**BEFORE
THE OHIO POWER SITING BOARD**

In the Matter of the Application of)
REPUBLIC WIND, LLC for a Certificate of)
Environmental Compatibility and Public Need) Case No. 17-2295-EL-BGN
for a Wind-Powered Electric Generating)
Facility in Republic and Sandusky Counties,)
Ohio.)

**SUPPLEMENTAL
DIRECT TESTIMONY OF**

**Benjamin M. Doyle
Capitol Airspace Group**

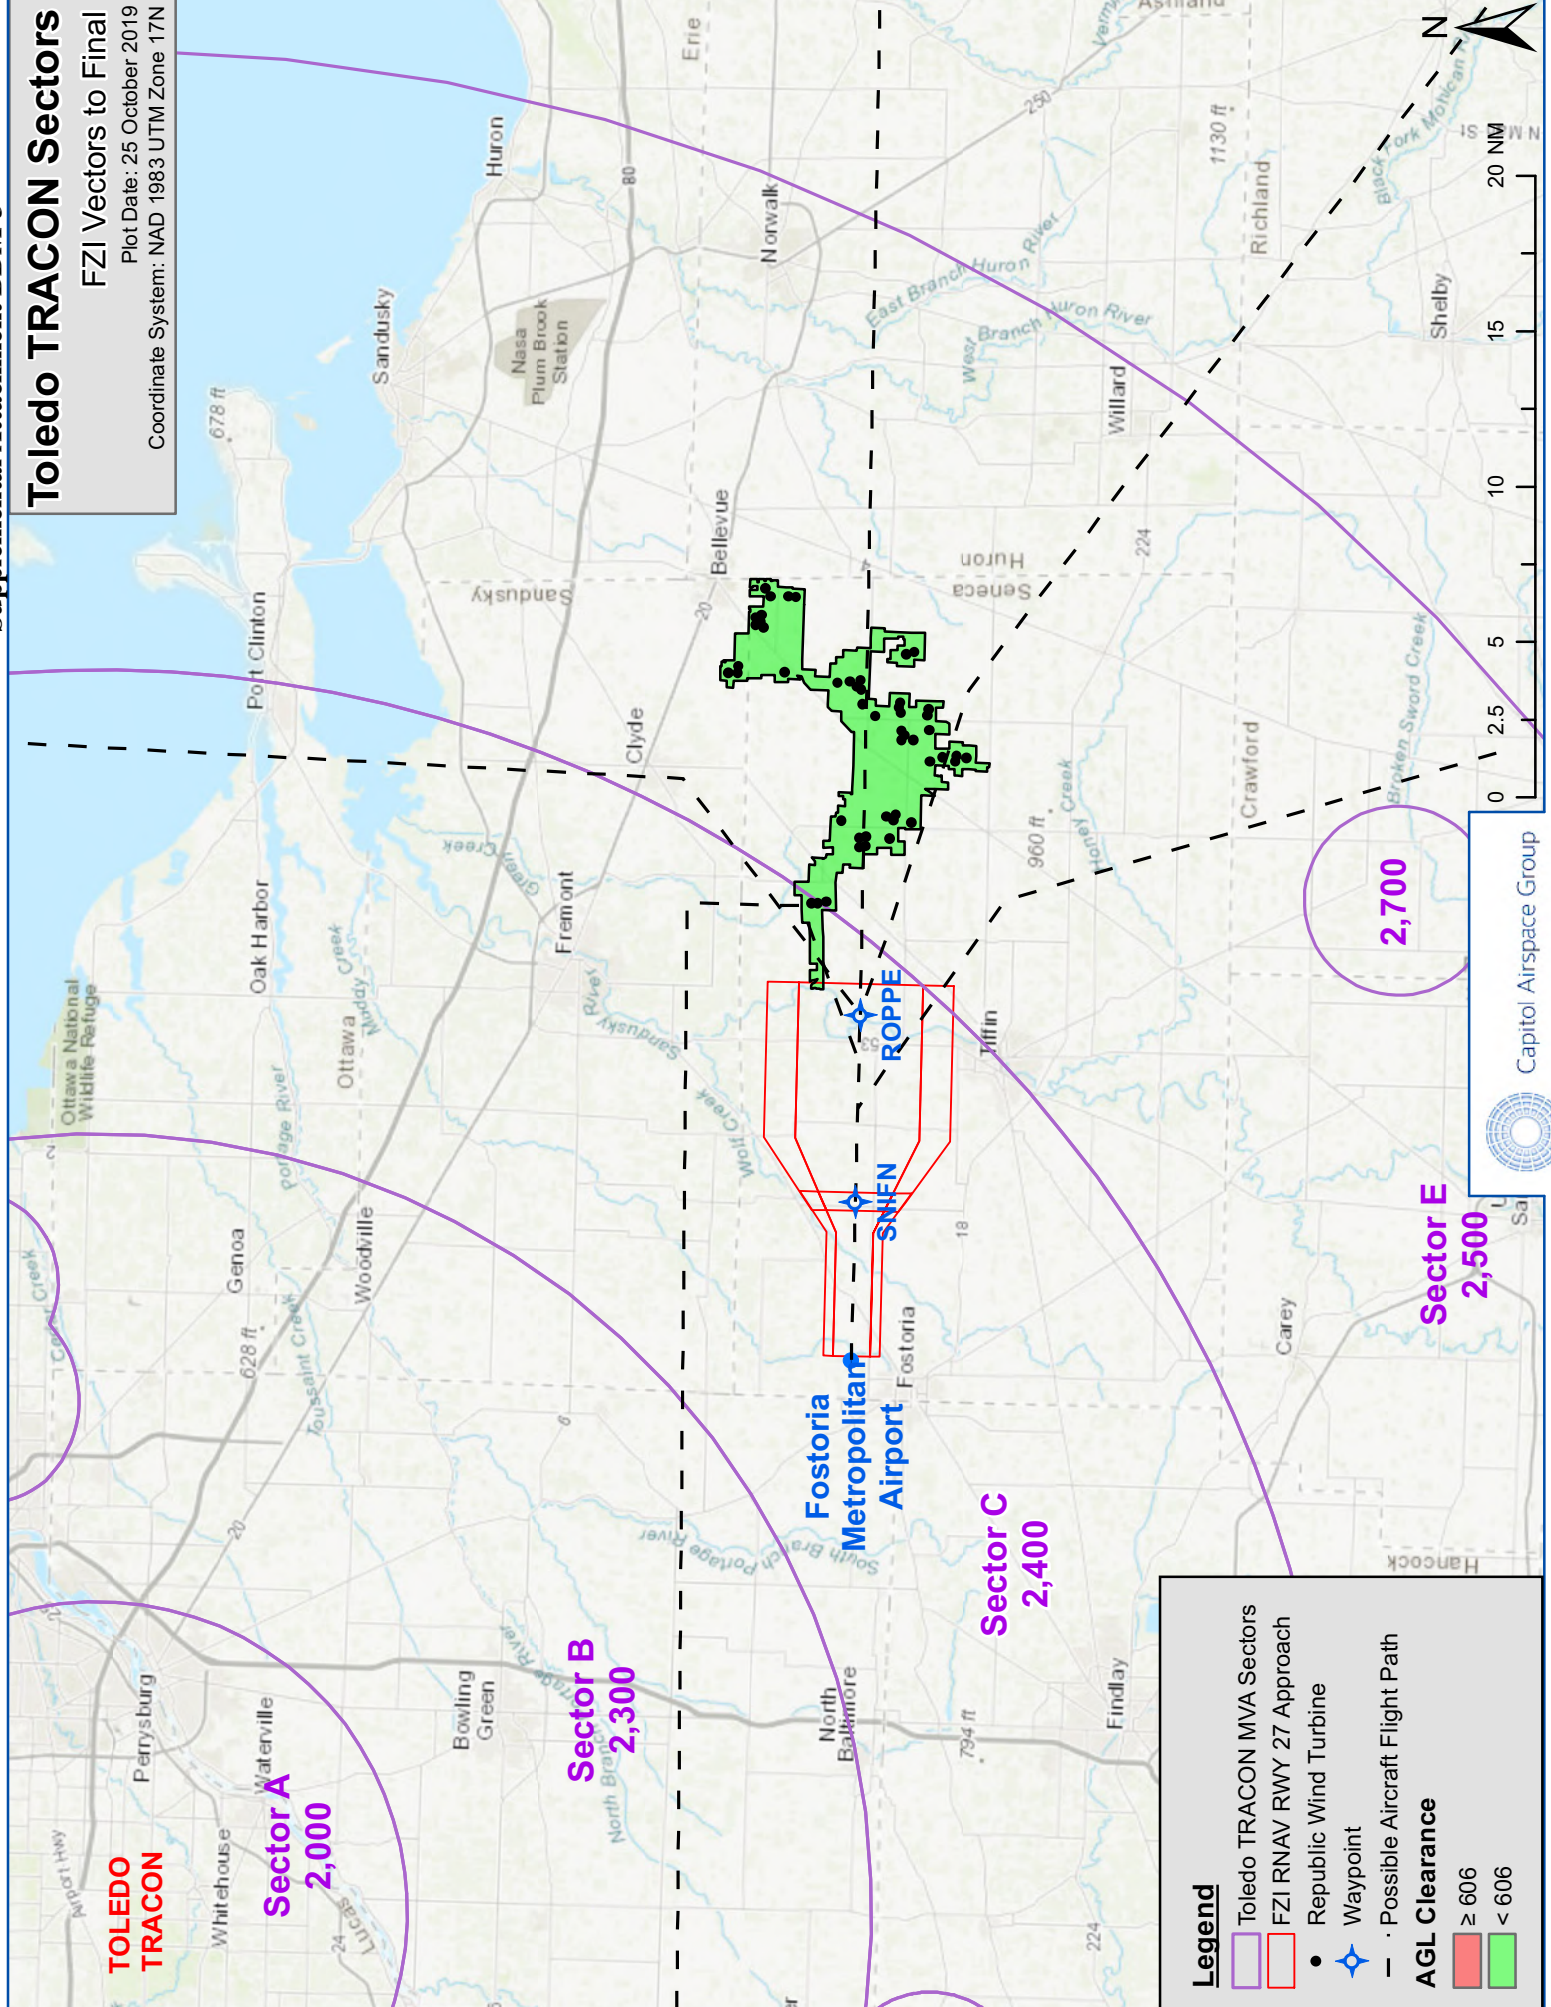
The minimum vectoring altitude for Fostoria Metropolitan Airport (FZI) by Toledo Approach is 2400 ft MSL, which coincides with the initial approach altitude of the GPS 27 approach. Frequently, the need to do the approach procedure is mitigated by the availability of doing the approach visually. On the surface it seems this is just a convenience issue, however, safety comes to the forefront, especially during the winter months. An aircraft approaching FZI, as a destination, is able to reduce the time spent in IMC Icing conditions because Toledo Approach is able to vector to final and ultimately descend the aircraft to 2300 ft MSL for the approach leg between ROPPE and SNIFN. Additionally, Bowling Green State University (BGSU) has 20+ aircraft that they use for instruction, including instrument instruction. Because of the instrument approaches available at FZI, the university uses the facility extensively for their instrument students. Any altitude increase to the instrument approaches requires them to spend more time in the icing conditions. Since 1971, the City of Fostoria has put significant effort and resources into the facility and surrounding airspace and is not in favor of relinquishing airspace protection, no matter how insignificant it may seem, to those who do not use the facility.

Toledo TRACON Sectors

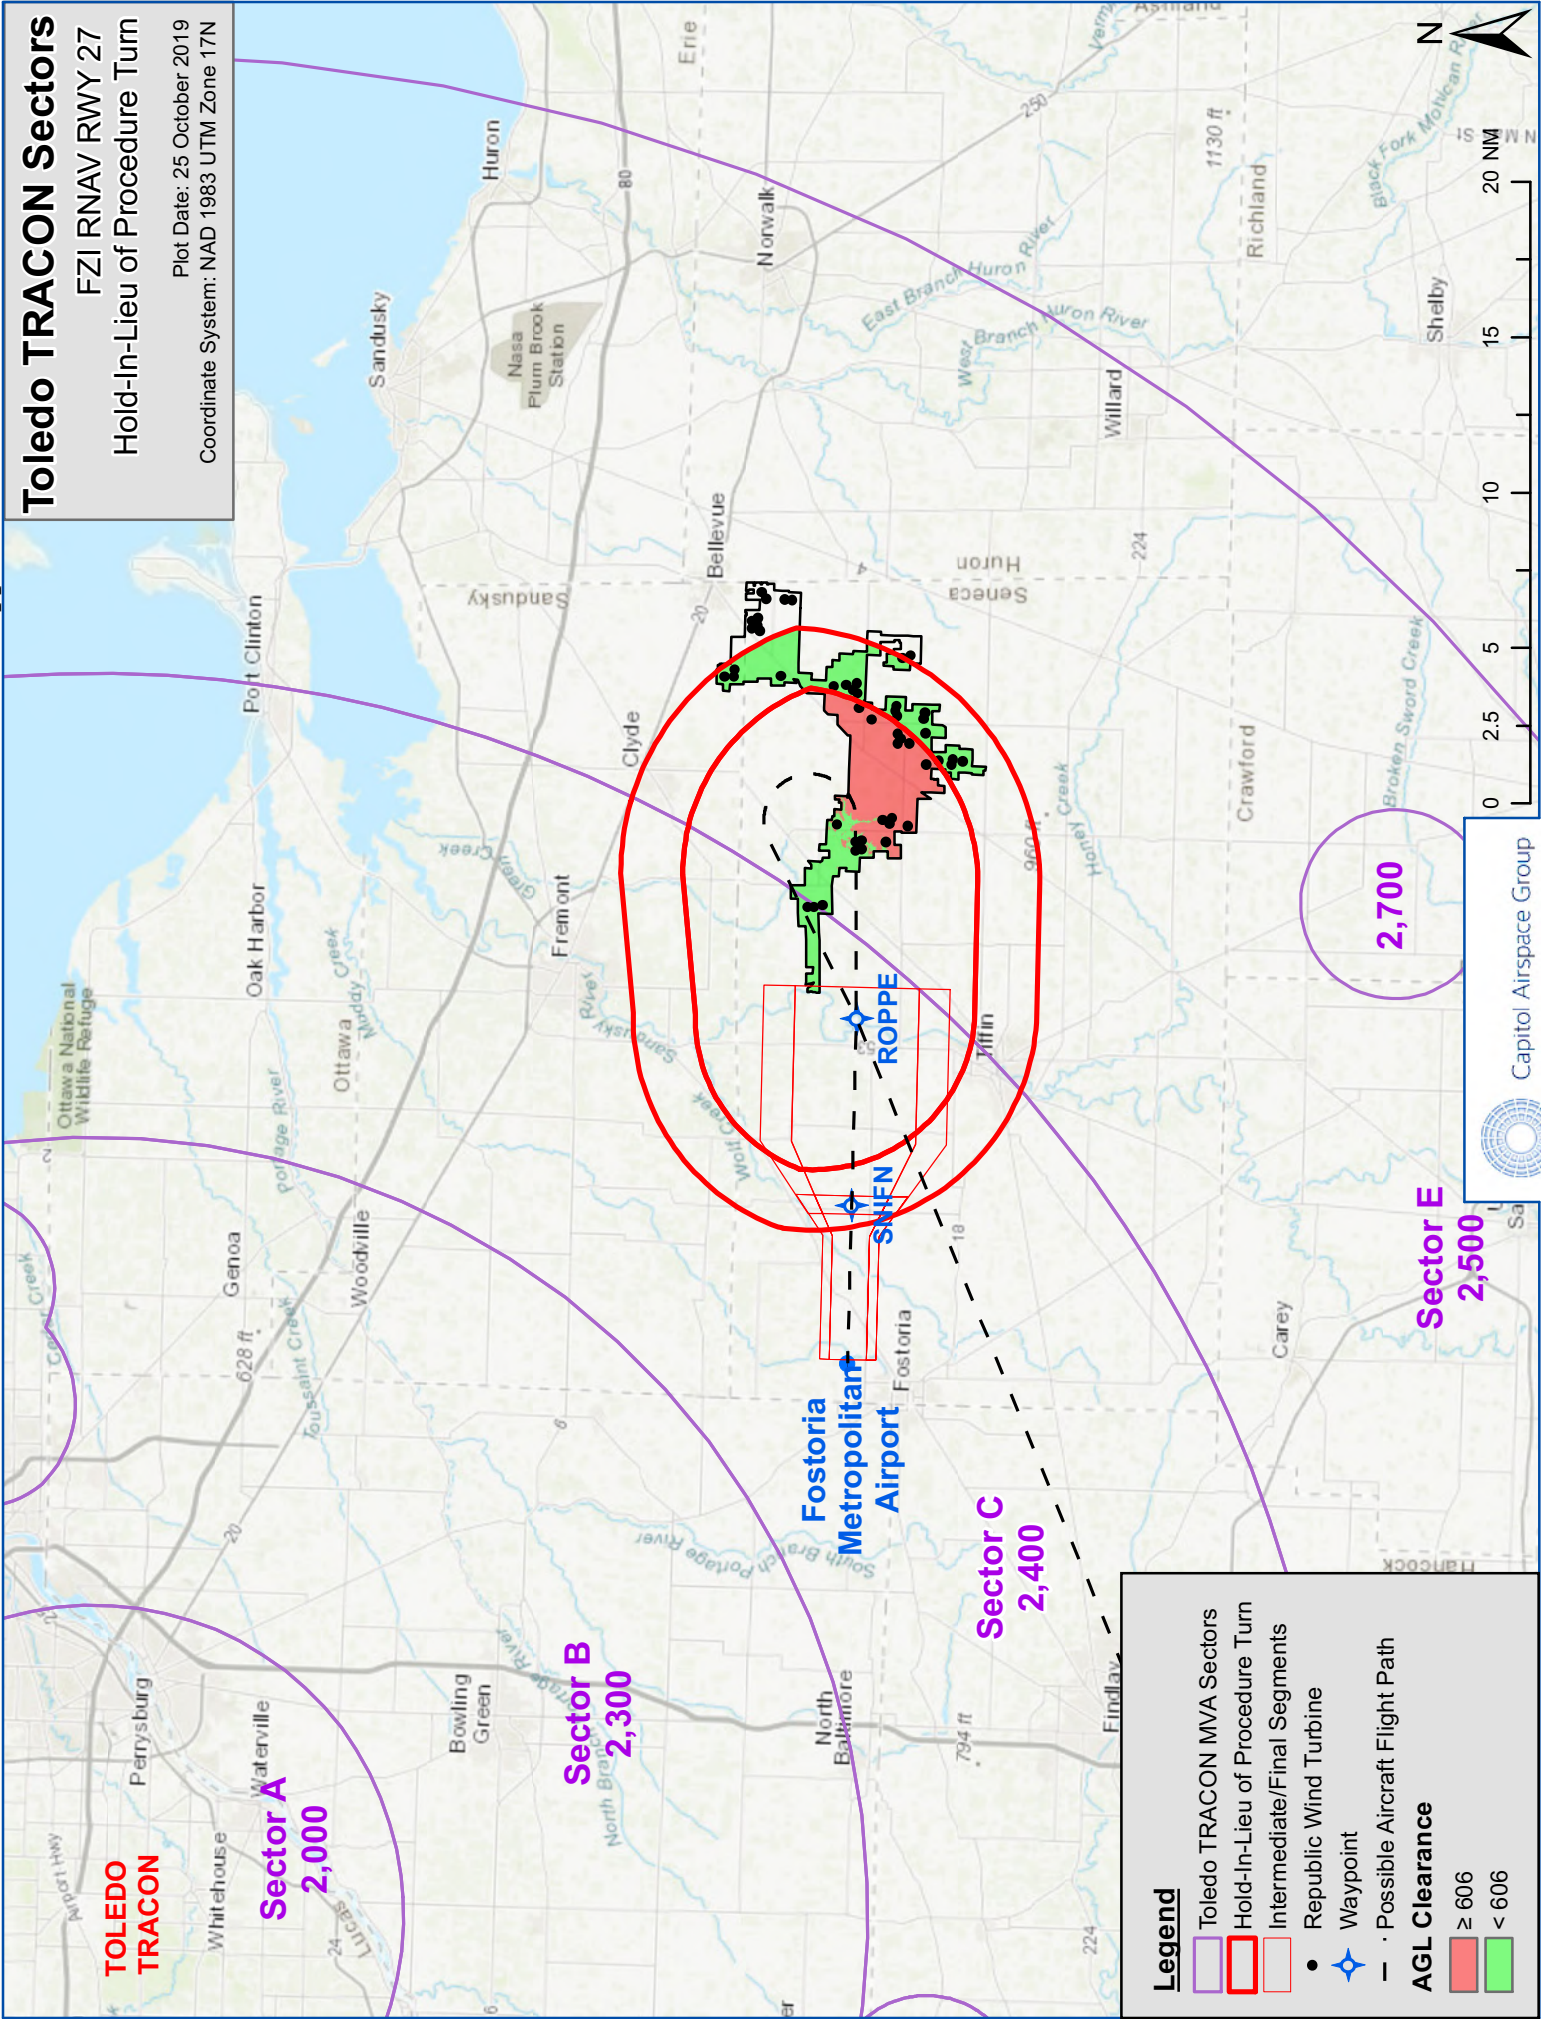
- 3) The minimum vectoring altitude (MVA) sector in the area of Fosteria Metropolitan Airport is unaffected and will remain at 2,400 feet AMSL. As a result, air traffic controllers can continue to provide radar vectoring services, as they have always done, for aircraft to intercept an extended centerline, before the final approach fix, at 2,400 feet AMSL.
